SERVICE BULLETIN

PURPOSE : CHANGE	ISSUE NO. : MSB-14EXML51-001A	DATE : 2014-01-30
SUBJECT : REMOVAL AND INSTALLATION OF FRONT BUMPER ASSEMBLY AND RADIATOR GRILL		<DESTINATION/MODEL> (As per attached sheet 1) <M/Y> 13-14
GROUP : EXTERIOR(Gr:51)		MIRAGE/SPACE STAR (A03A)

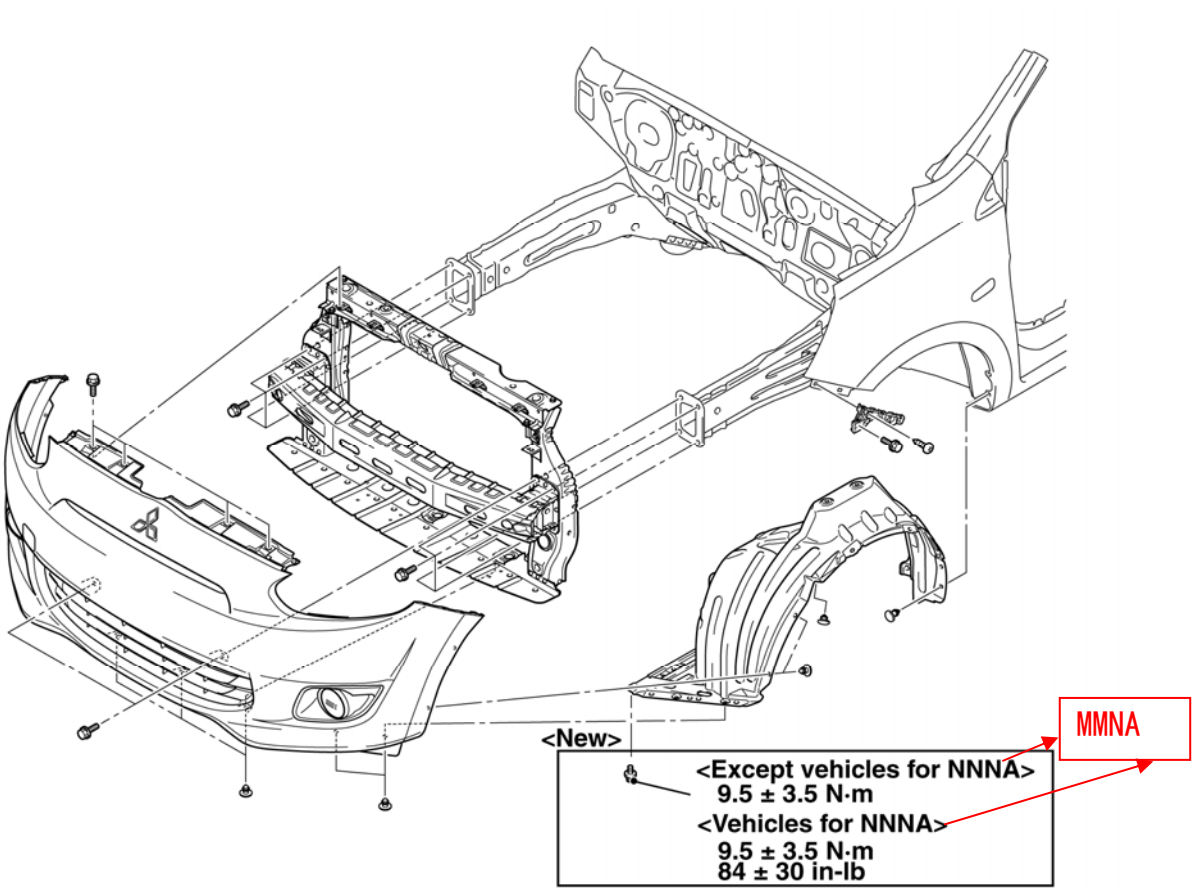
Please refer to the attached document for the information about the change of mention in the applicable service manual.(The clip used for installation of the splash shield is changed to the bolt with washer)

Please refer to the following illustration.
This change is applicable to the vehicle produced after the middle of May 2013.
